DETERMINATION OF NON-SIGNIFICANCE

PROPONENT:
Cara Godwin, Ankrom Moisan Architects
LOCATION OF PROPOSAL:
939 Bellevue Way NE, Bellevue, WA

City of Bellevue
Department of Planning and Community Development
Land Use Division Staff Report

Proposal Name:	Avalon @ NE 10th Street
Proposal Address:	939 Bellevue Way
Proposal Description:	Design Review application for a 19-story residential tower and a 9-story residential tower with 398 combined units above a 4-story retail base and partially underground parking.
File Number:	07-122343-LD
Applicant:	Cara Godwin, Ankrom Moisan Architects
Decisions Included:	Process II, Combined Design Review and SEPA
Planner:	Mike Upston, AICP
State Environmental Policy Act Threshold Determination:	**Determination of Non-significance**

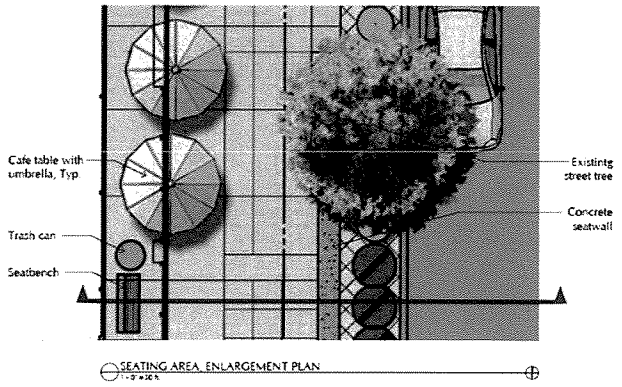
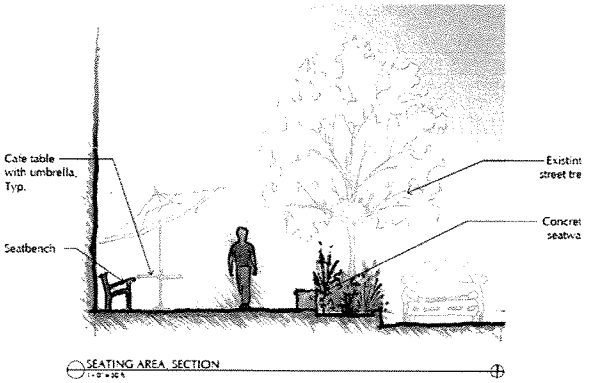
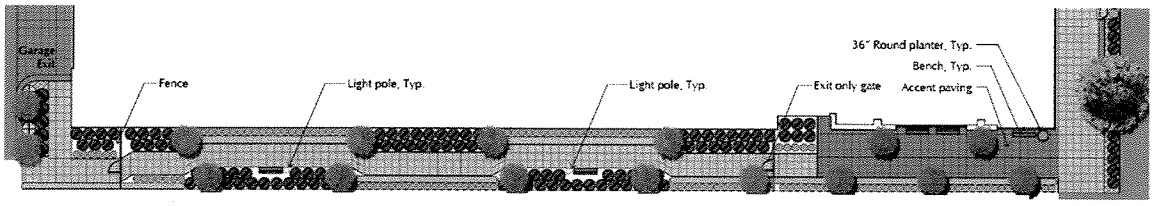
- The plans now depict this project's contribution to the required north-south mid-block pedestrian connection (refer to attached plan sheet 28).
- The plans now depict the portion of east-west mid-block pedestrian connection to be constructed by Avalon with this project (refer to the bottom drawing below; the portion to be built by Avalon now is denoted with red/brown paving and red trees). Construction of the rest of this connection will be required by the property owner to the immediate south when that property redevelops. The bottom drawing depicts what the completed east-west connection might look like when the Pier 1 property redevelops.

- A small outdoor space is provided on Bellevue Way at the SE corner of the site, setting the tone for the future east-west mid-block pedestrian connection. See the bottom drawing above and attached plan sheet 28.

FLOOR PLAN - LEVEL 1
SCALE: 1"=30'-0"

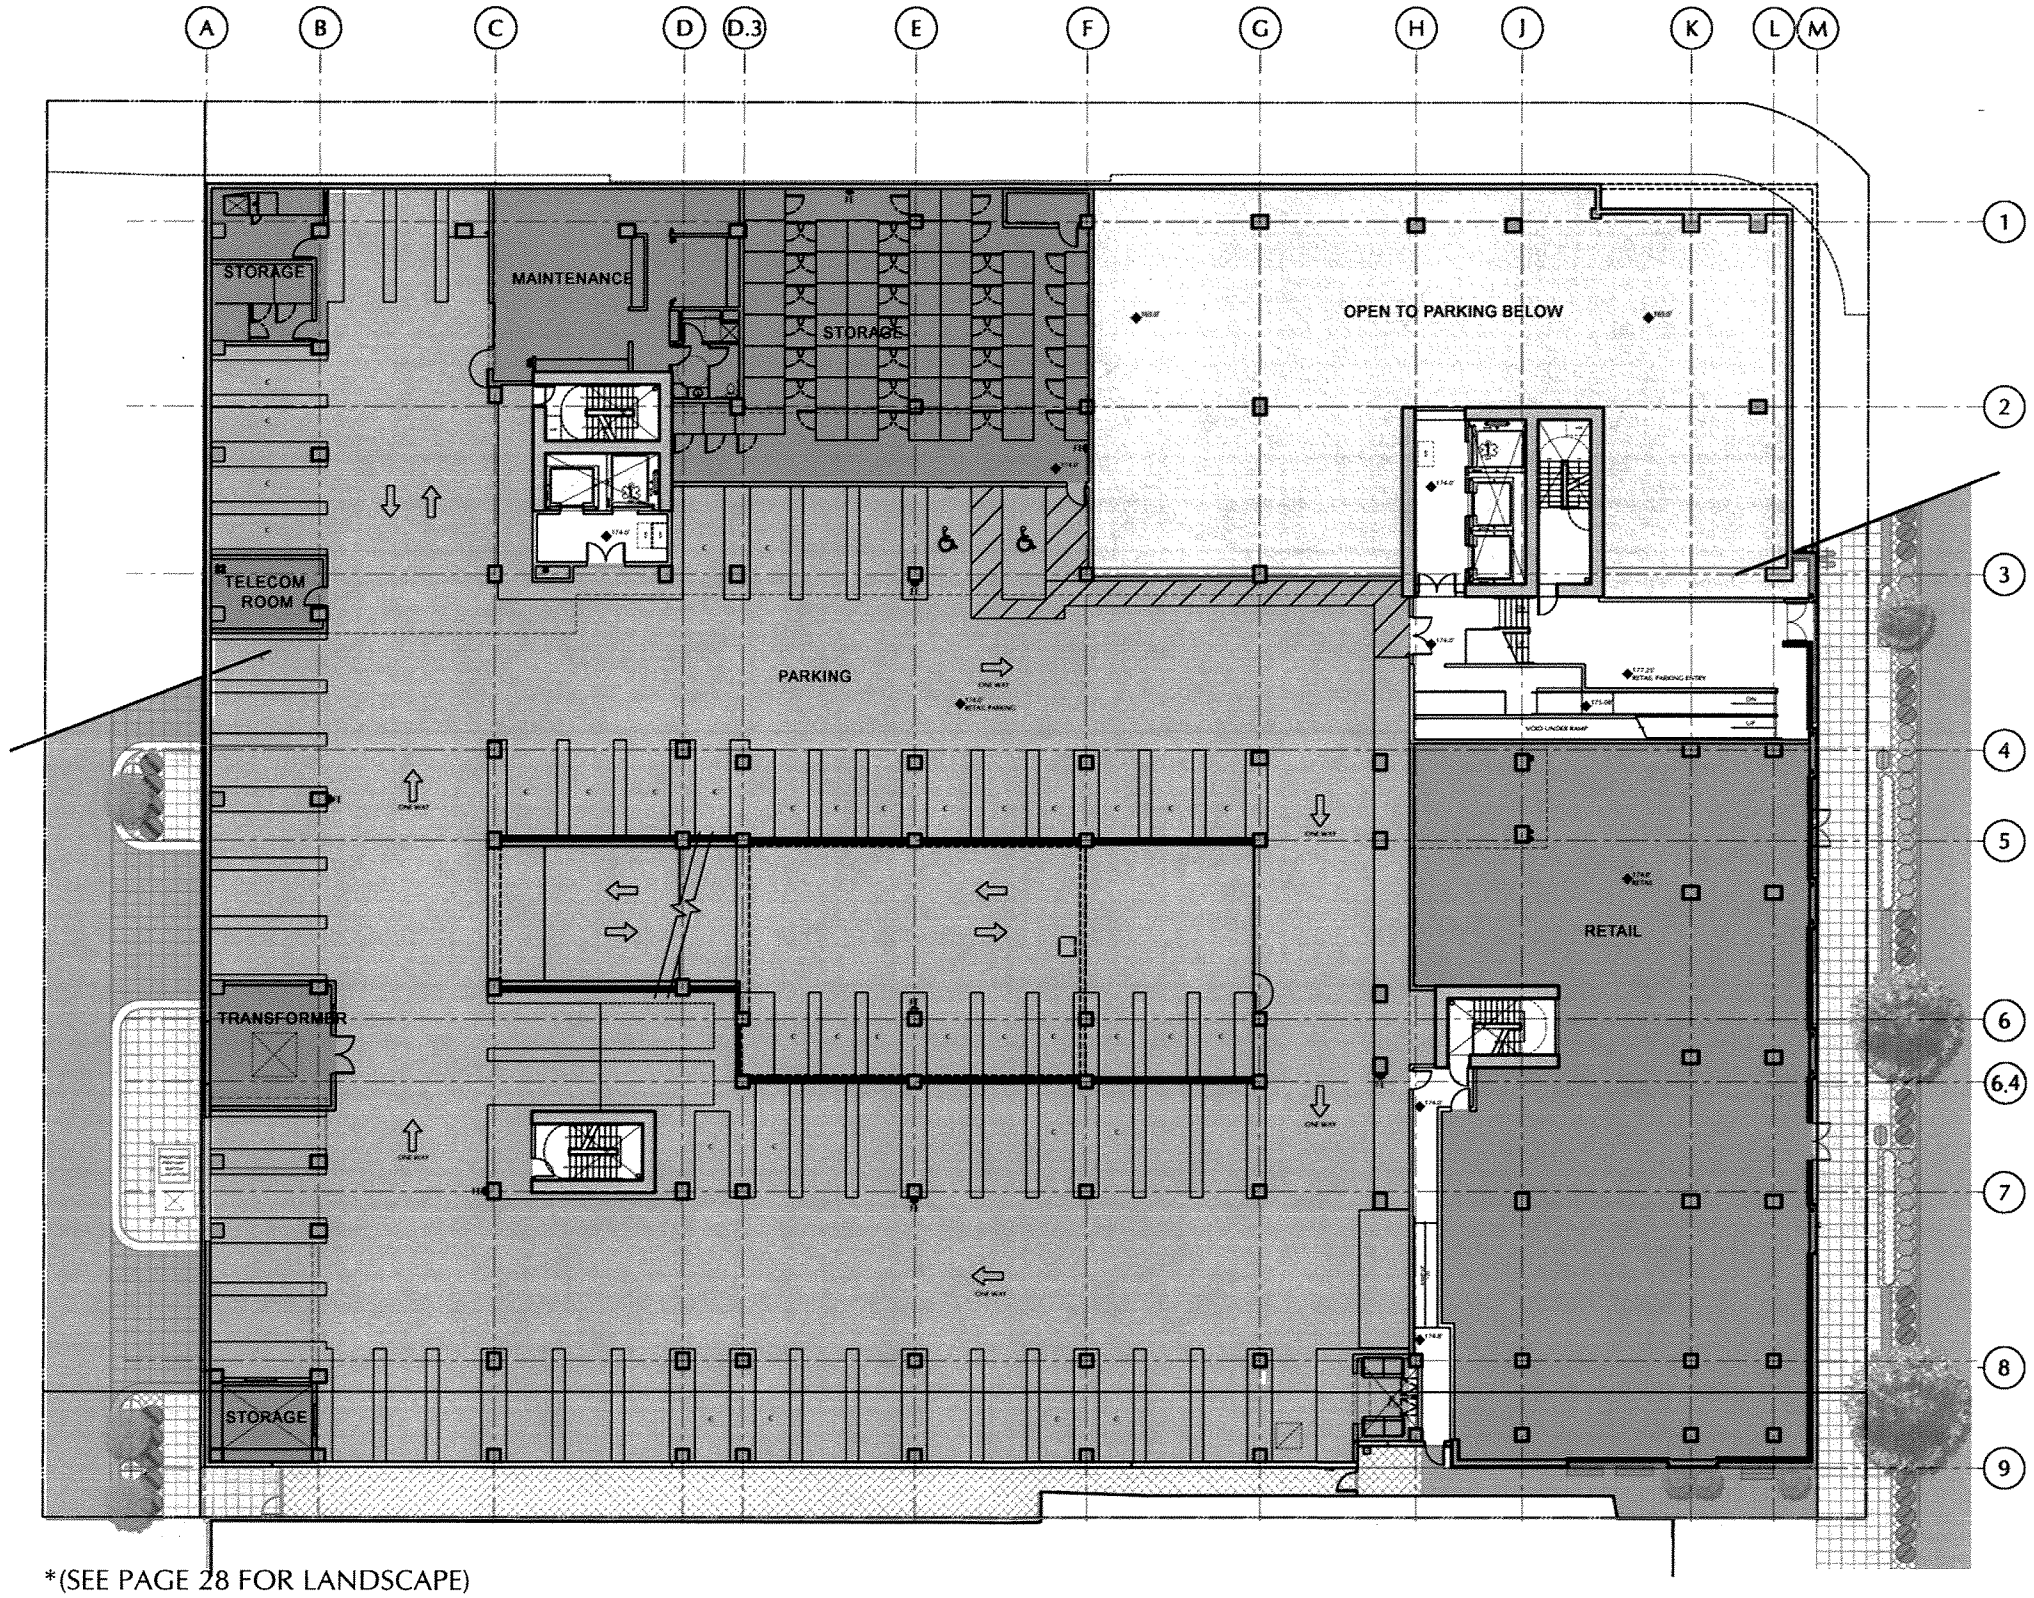
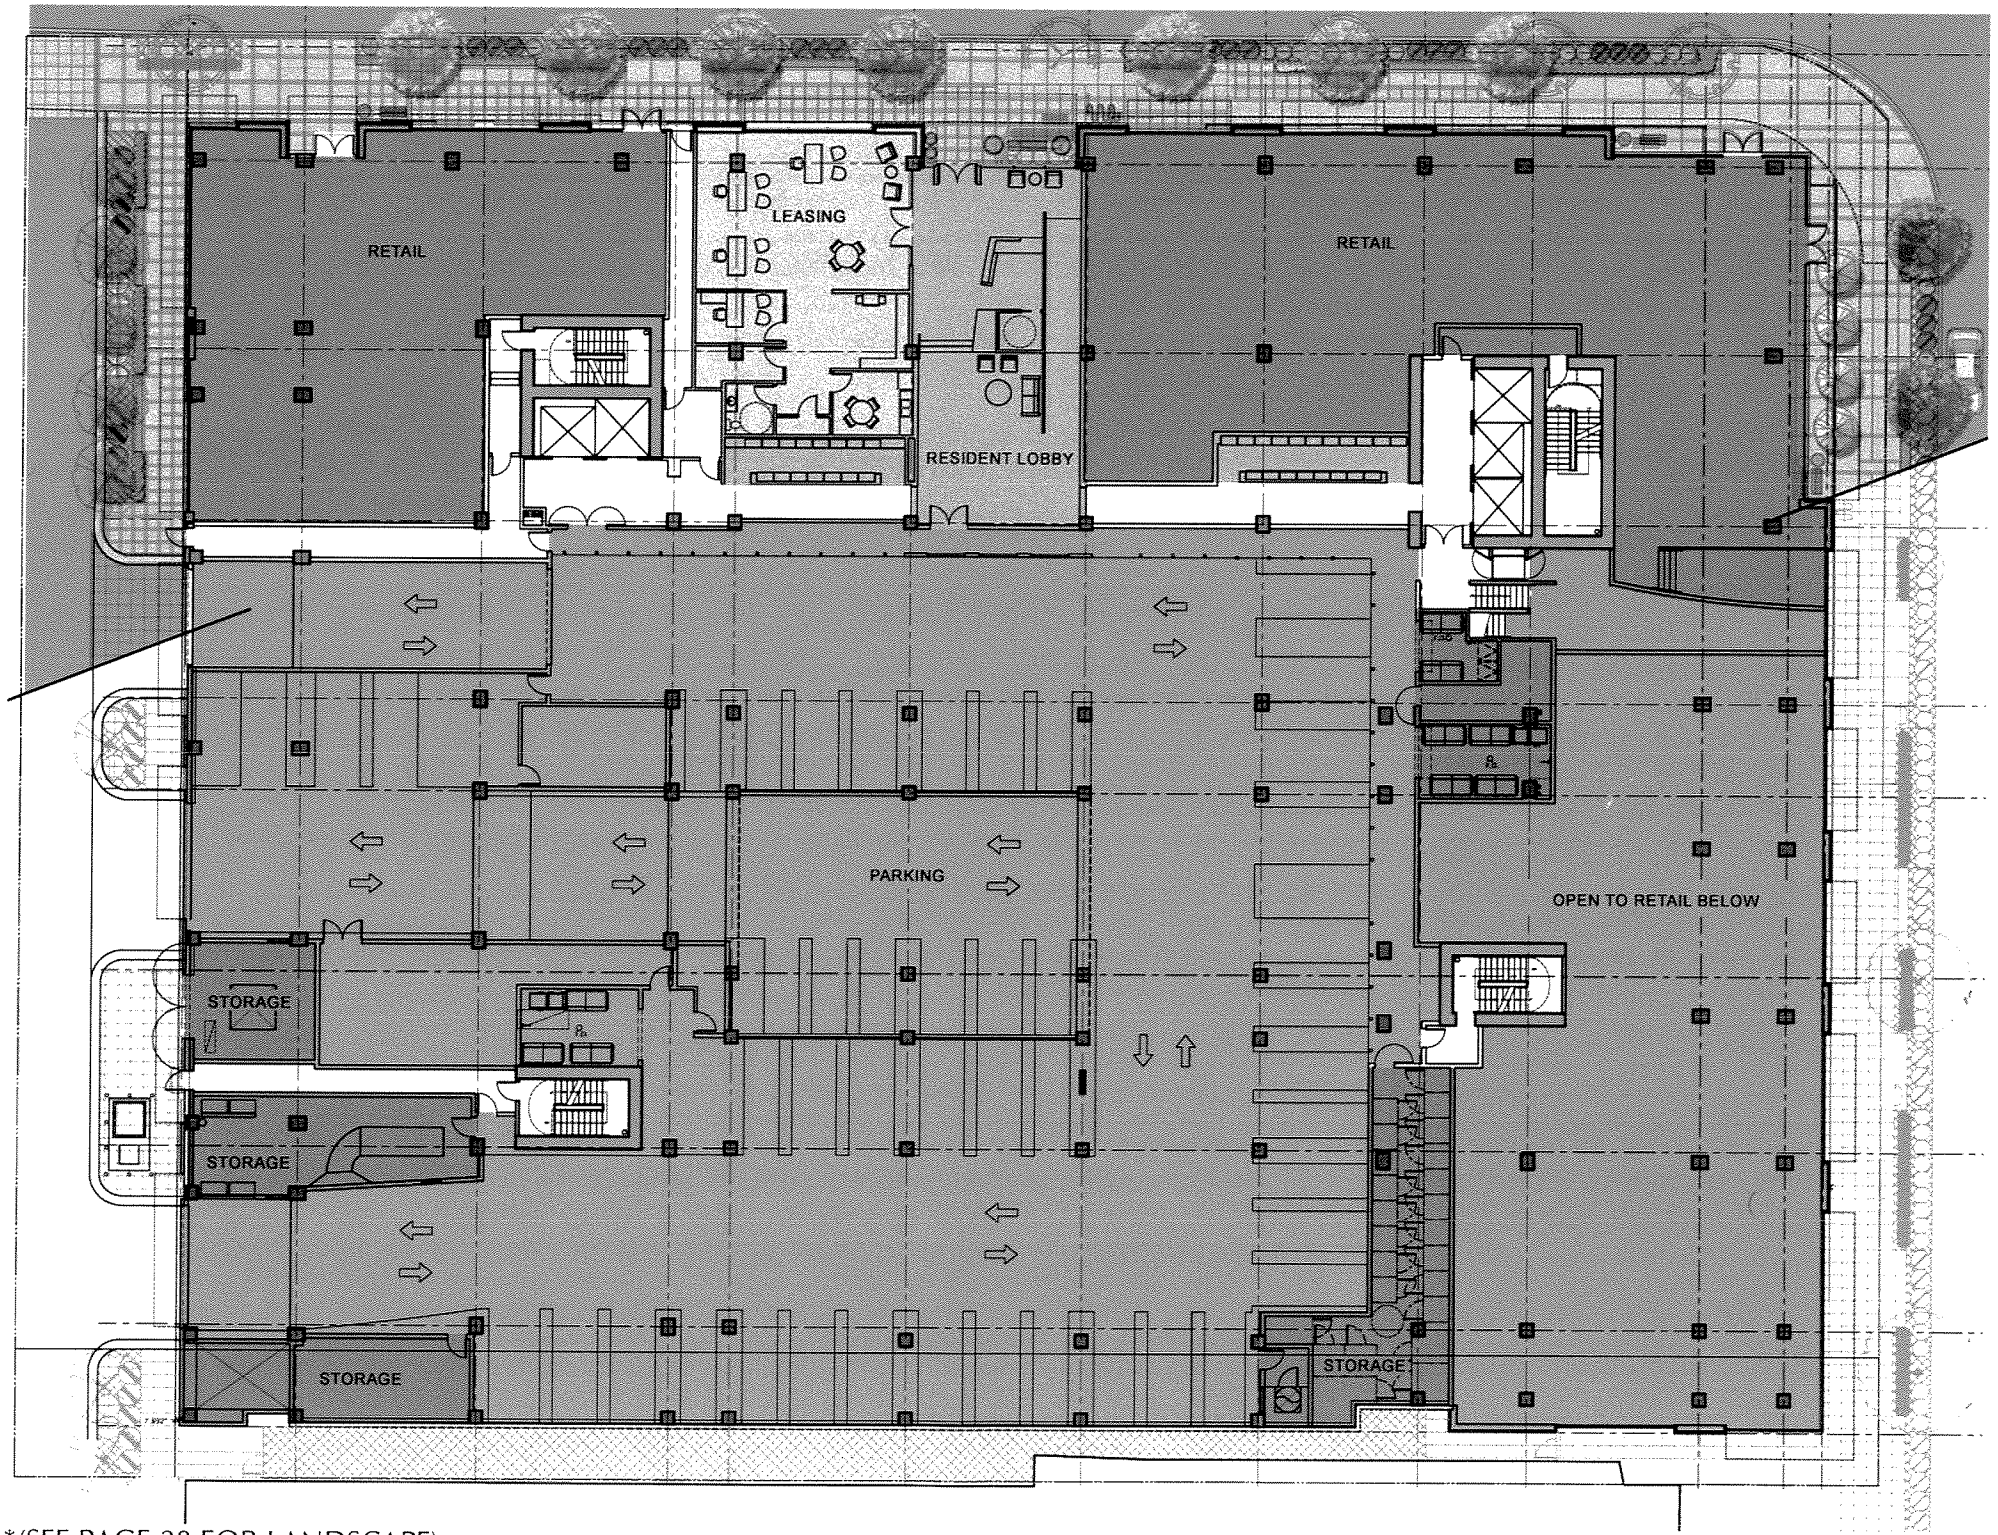
Site Access
The width of the proposed driveway off NE 10th Street as depicted on the Design Review plans is not adequate; it needs to be at least 26 feet wide for the first 100 feet into the site measured from the back of the new sidewalk, and accommodate all required vehicular turning movements.

- The ground floor now has retail frontage wrapping the southeast corner of the building to highlight the retail to pedestrians moving south on Bellevue Way. See plan sheet 21.

h) Driveway Width. The driveway on NE 10th Street shall have an approach width, as defined in standard drawing DEV-6, of at least 26 feet wide for the first 100 feet into the site measured from the back of the new sidewalk, and accommodate all required vehicular turning movements. The driveway apron design shall be consistent with standard drawing DEV-6.

ELEVATION - EAST
SCALE: 1"=30'-0"

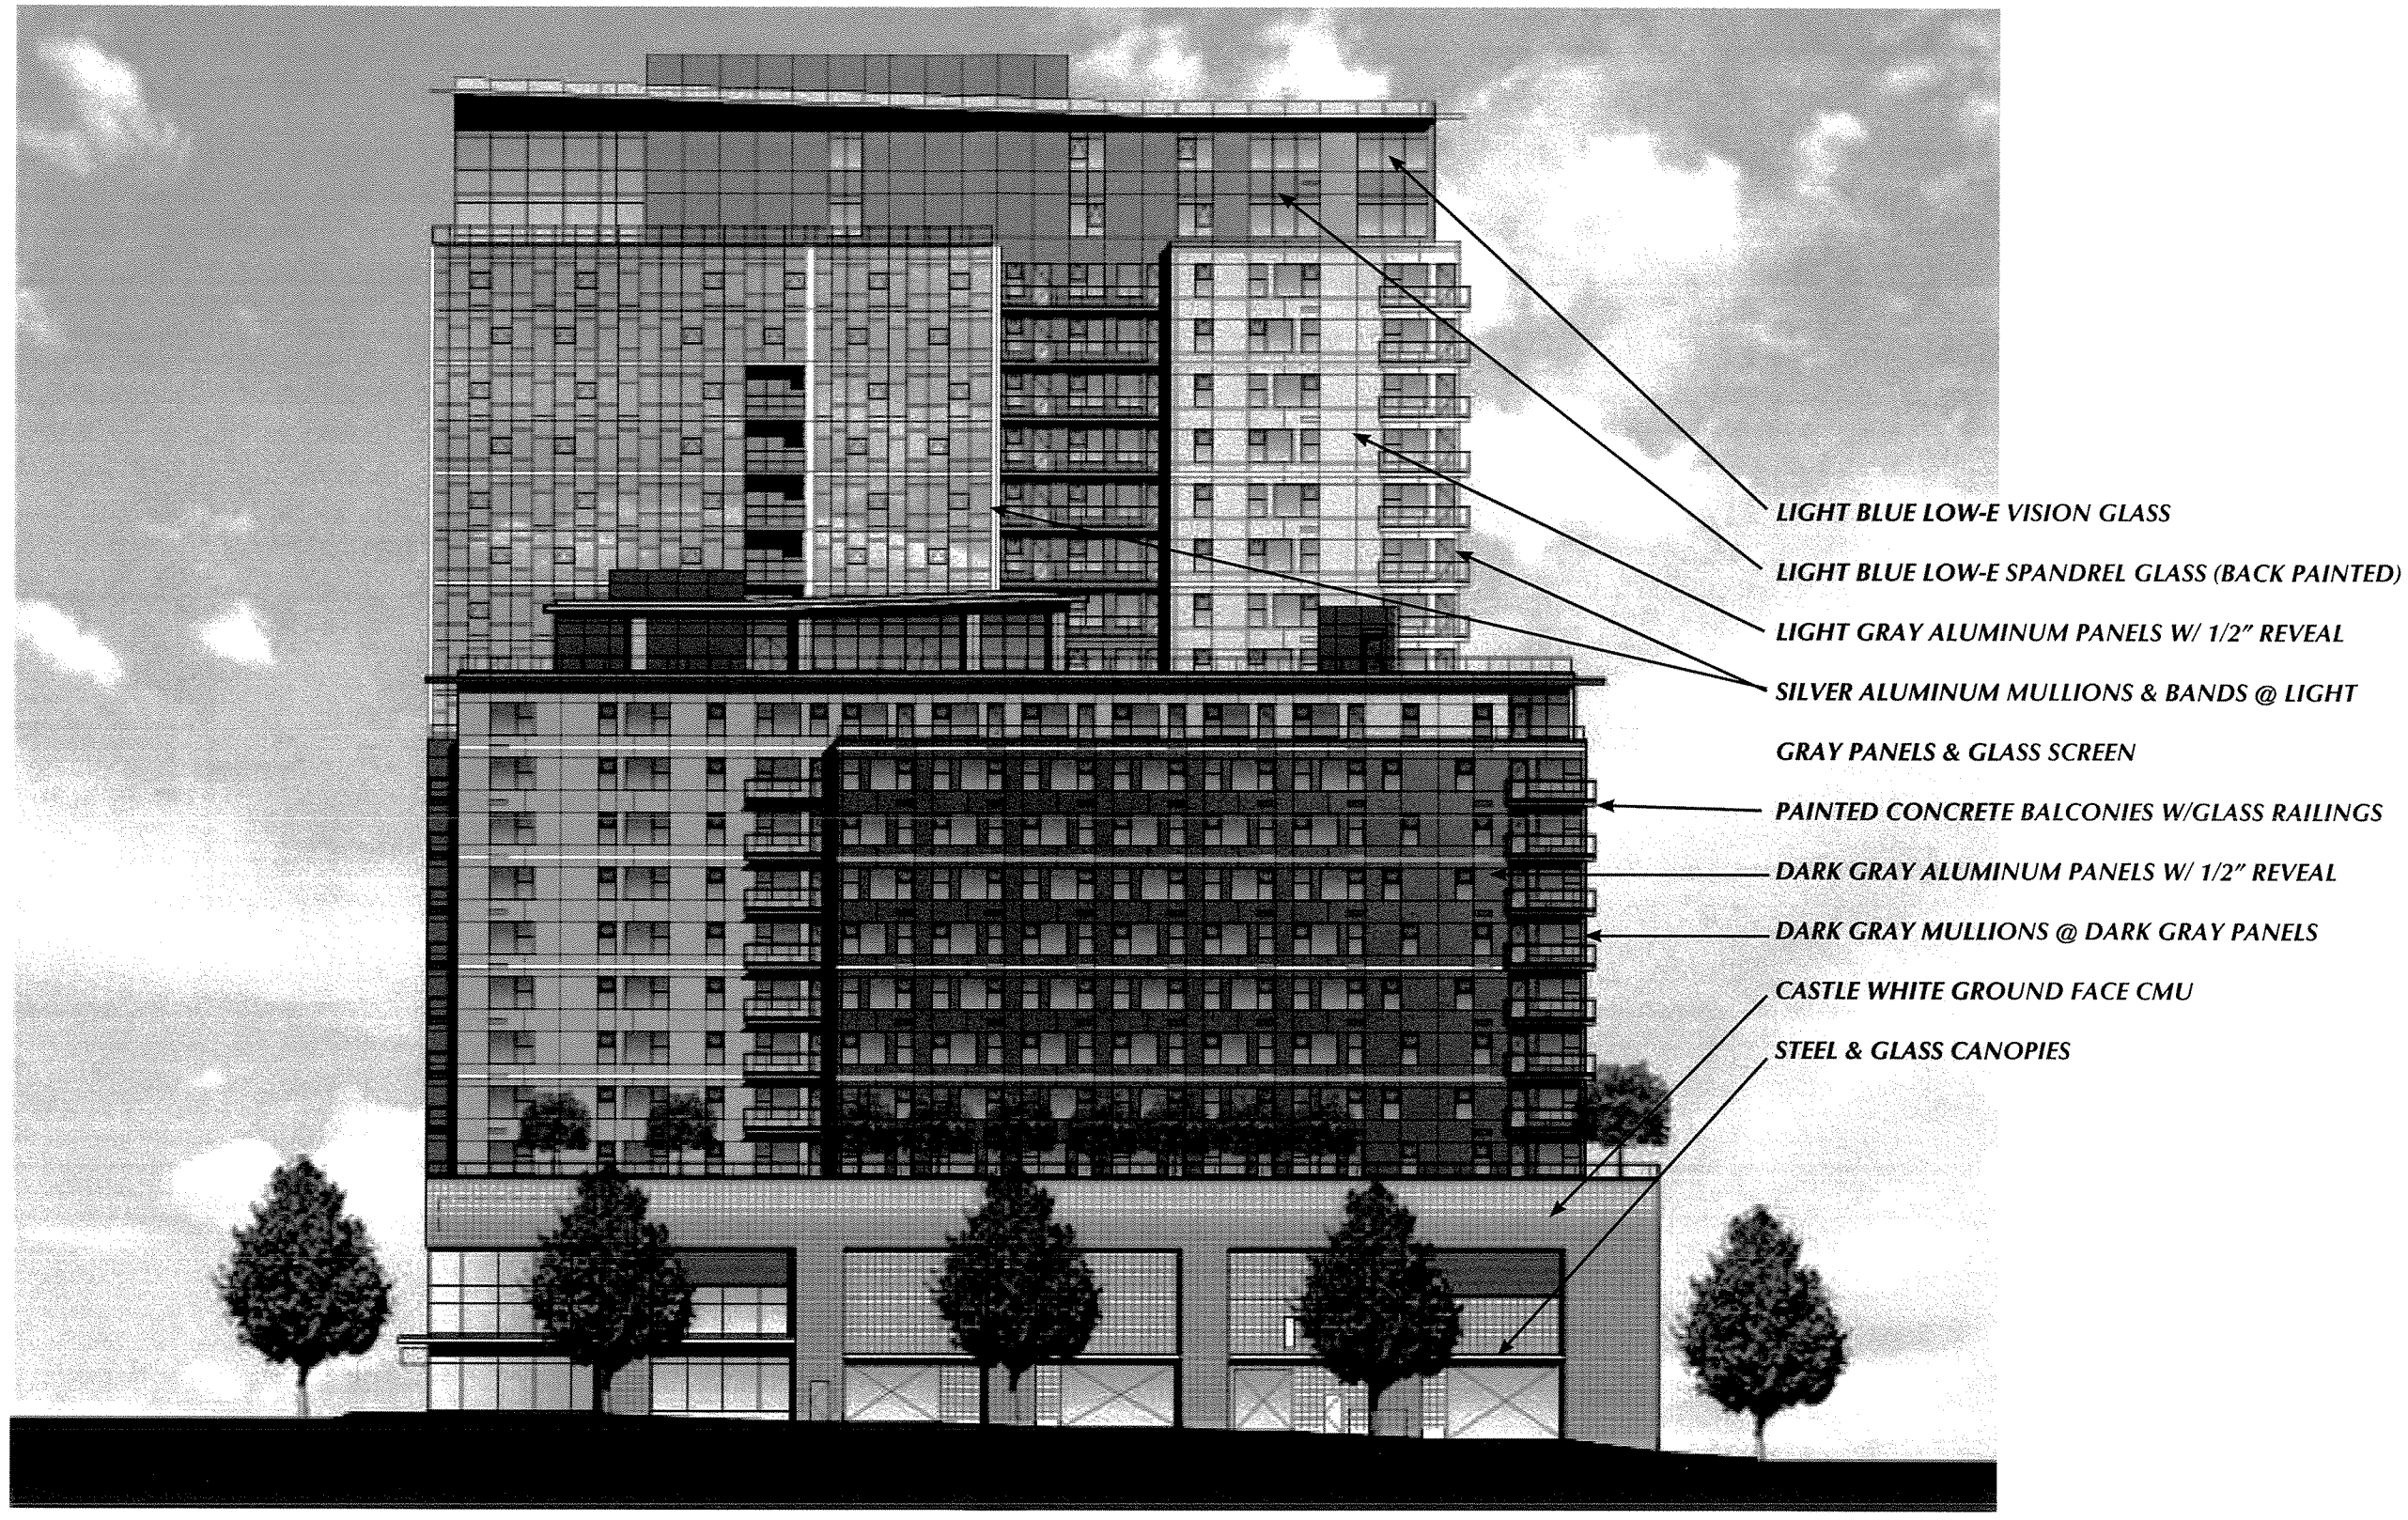
- The proportion of materials applied to the taller tower's east elevation has been tailored to improve the building's scale along Bellevue Way. See attached plan sheets 9, 18 and 26.
